**CITY OF PORTLAND, ME  
BOCA 1996 Plan Review Record  
One and Two Family Dwelling**

Building Location: 12 Willow Ln. (Lot #17) CBL: 190-K-030

## BUILDING PERMIT REPORT

DATE: 12 Dec, 98 ADDRESS: 12 Willow Ln Cot, #17 CBL 190-K-030  
REASON FOR PERMIT: To Construct a Single Family Dwelling  
BUILDING OWNER: Cottage Park Inc.  
CONTRACTOR: Ric Weinschenk Builders Inc.  
PERMIT APPLICANT: 1  
USE GROUP R-3 BOCA 1996 CONSTRUCTION TYPE 5-B

FRONT ELEVATION

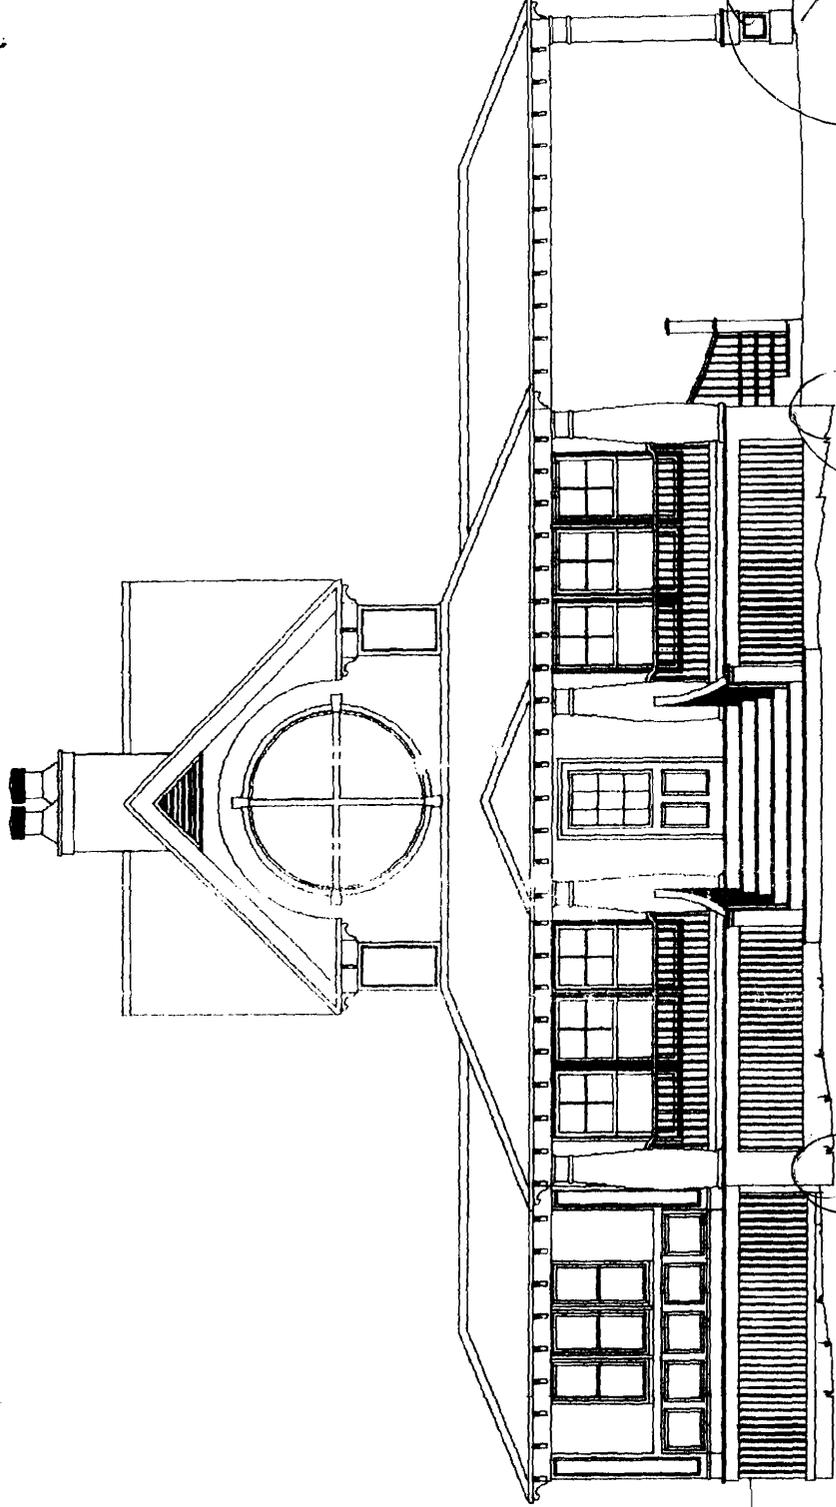
Foundation?

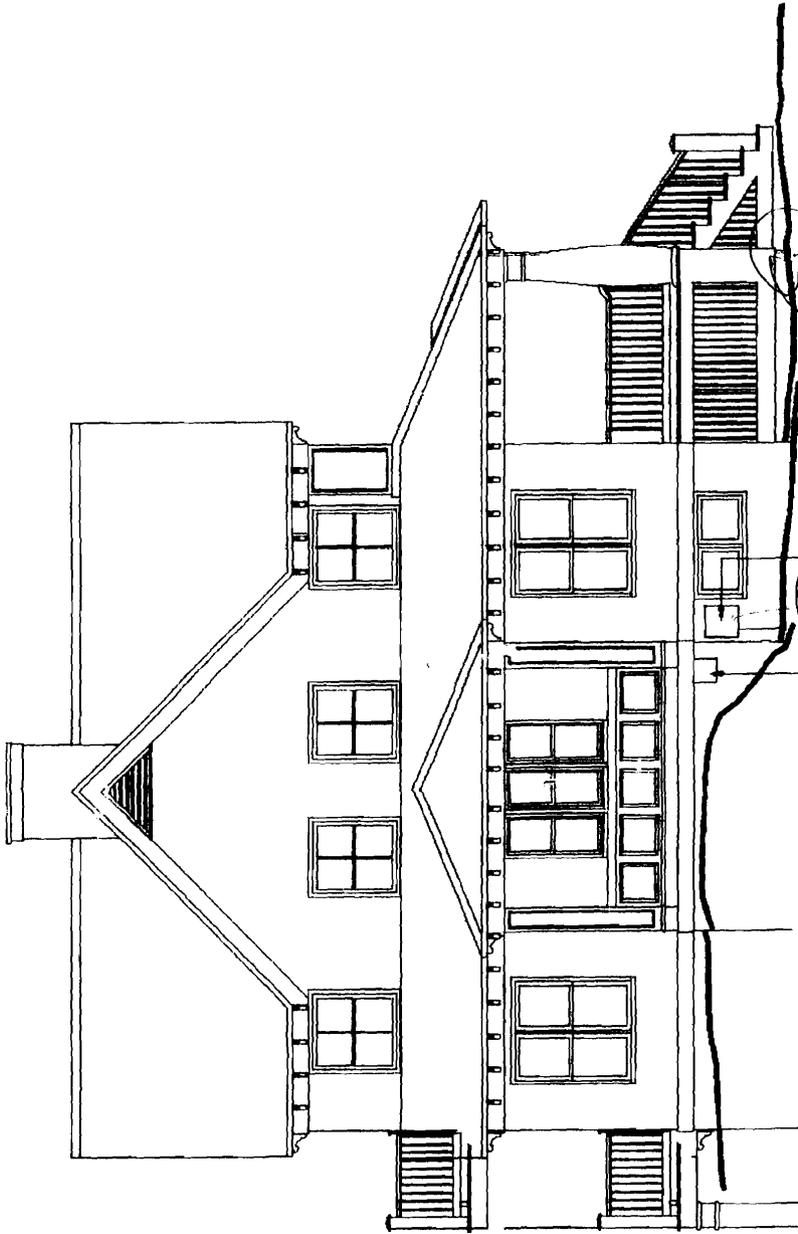
Foundation?

PELKEY RESIDENCE  
foundation plan

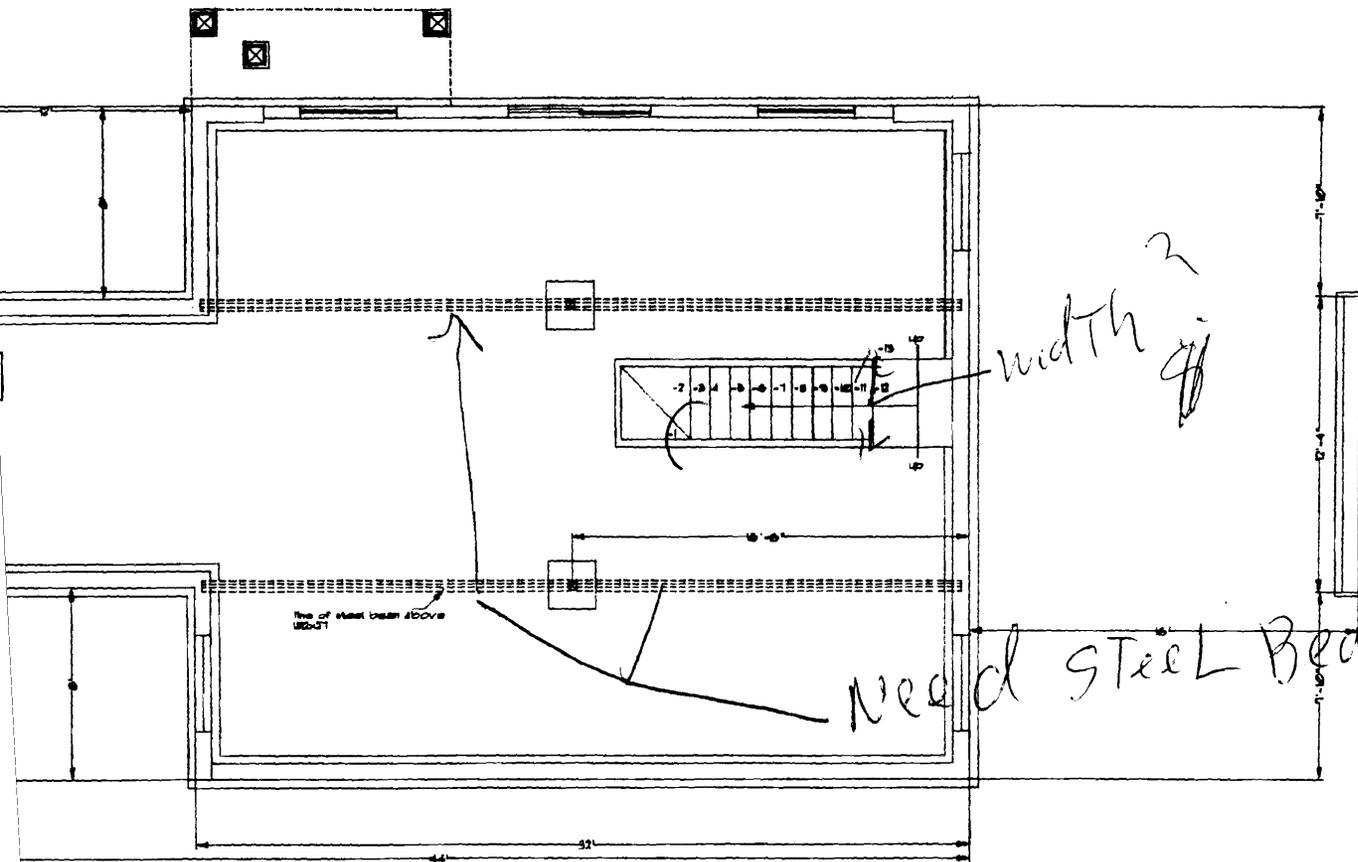
width 3'  
Need Steel Beam design by MANUF.

KEY RESIDENCE  
first floor

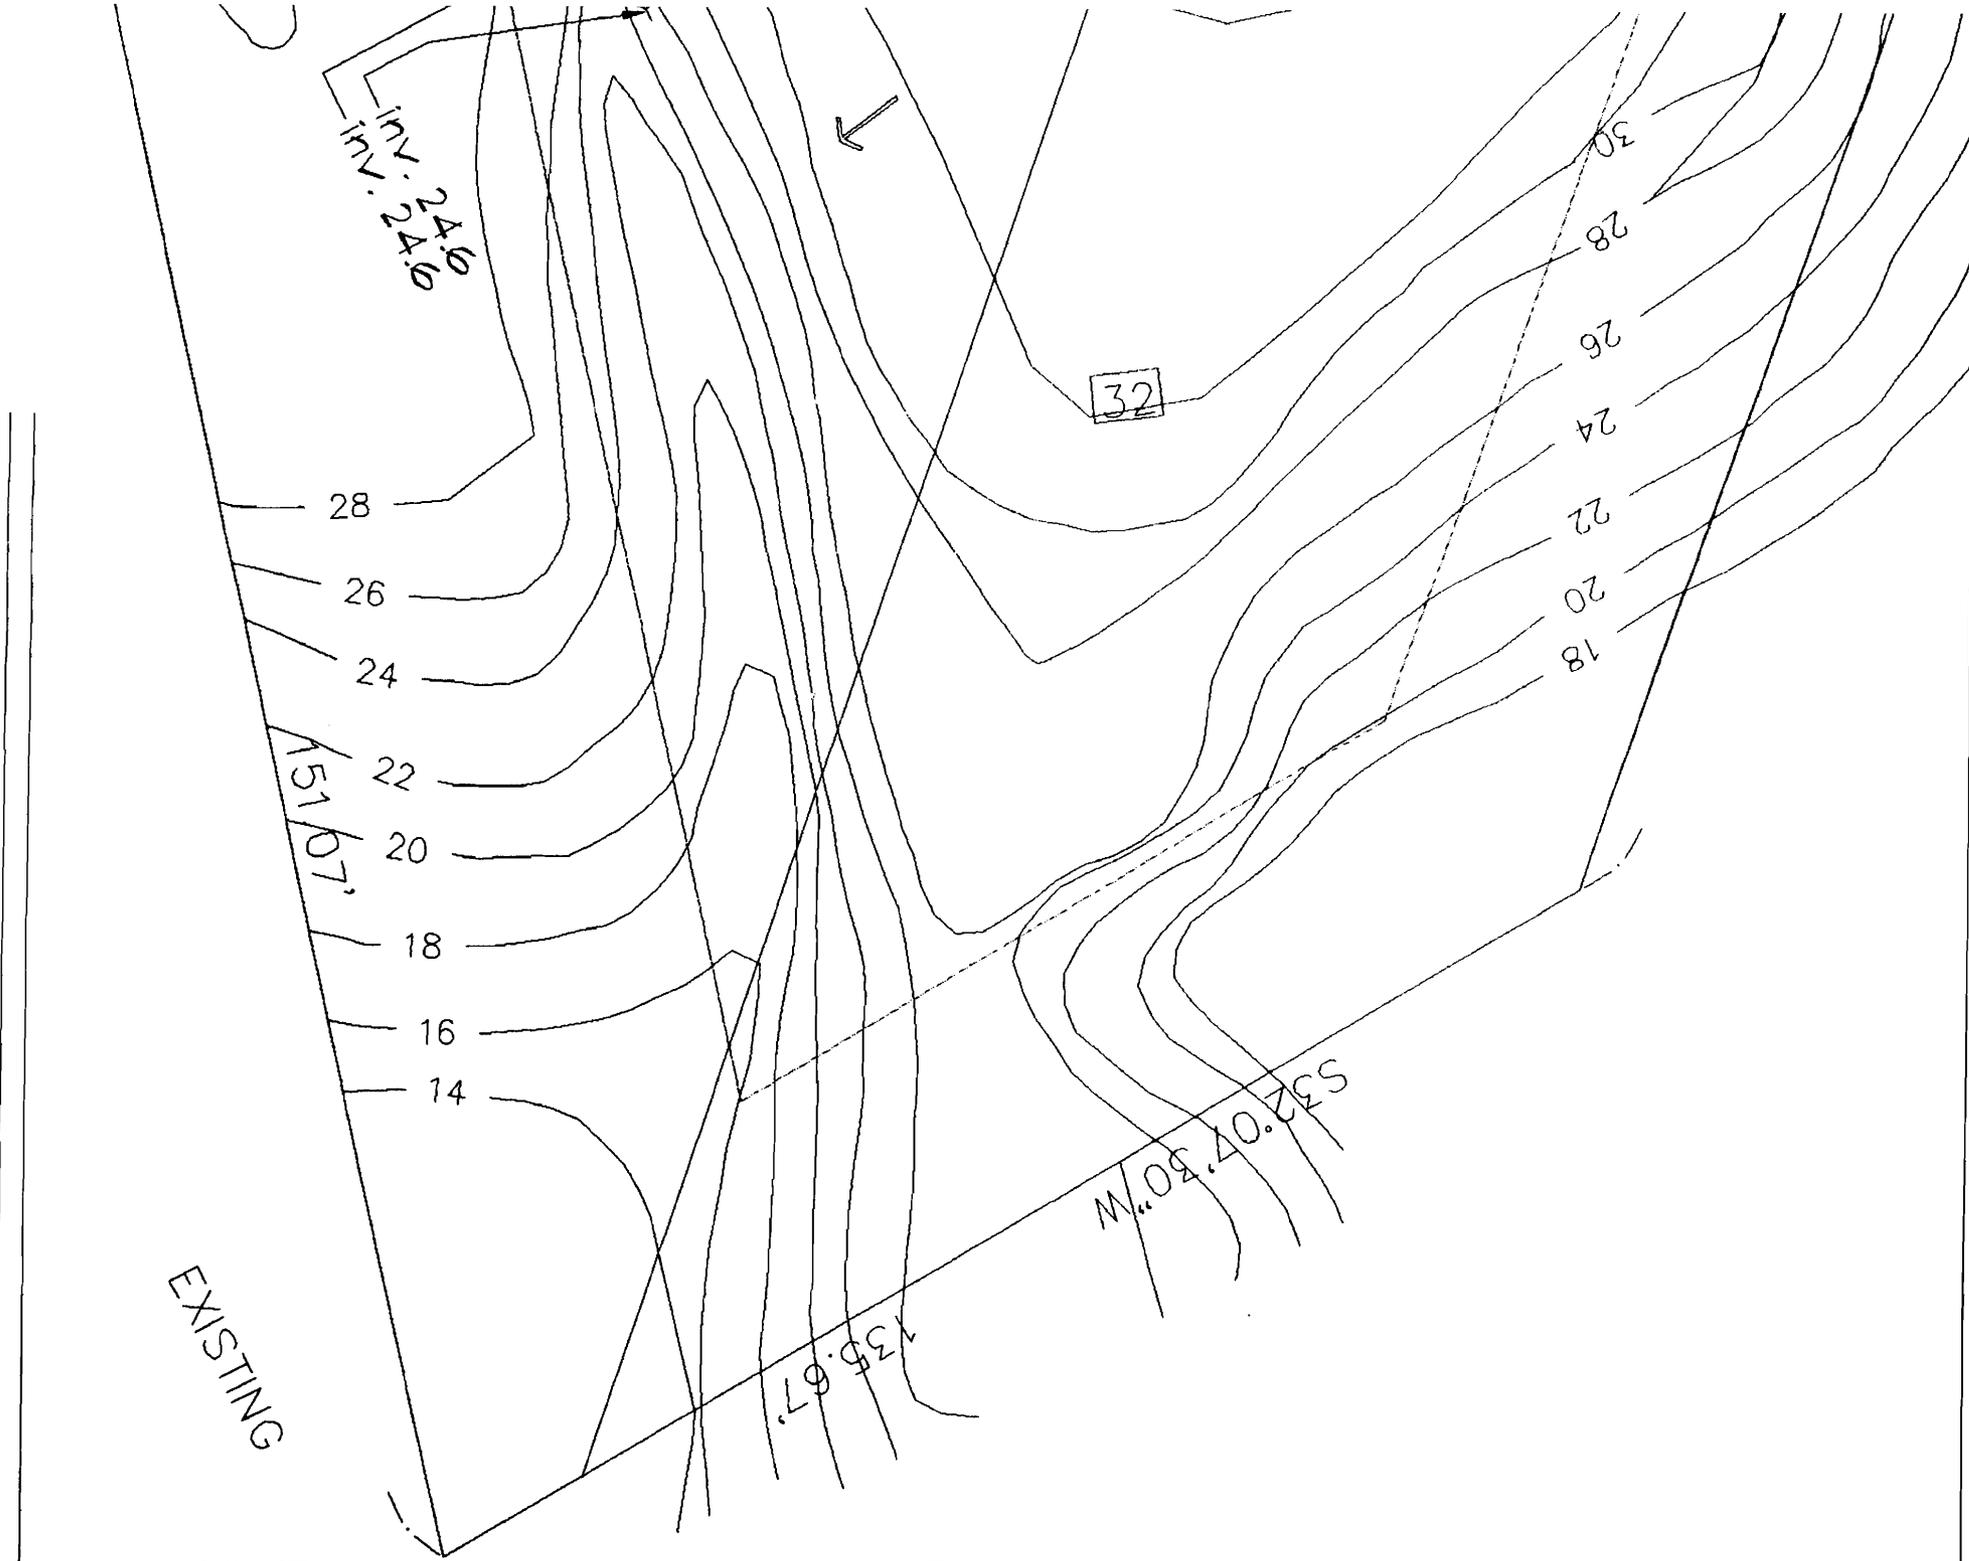
Foundations?  
H
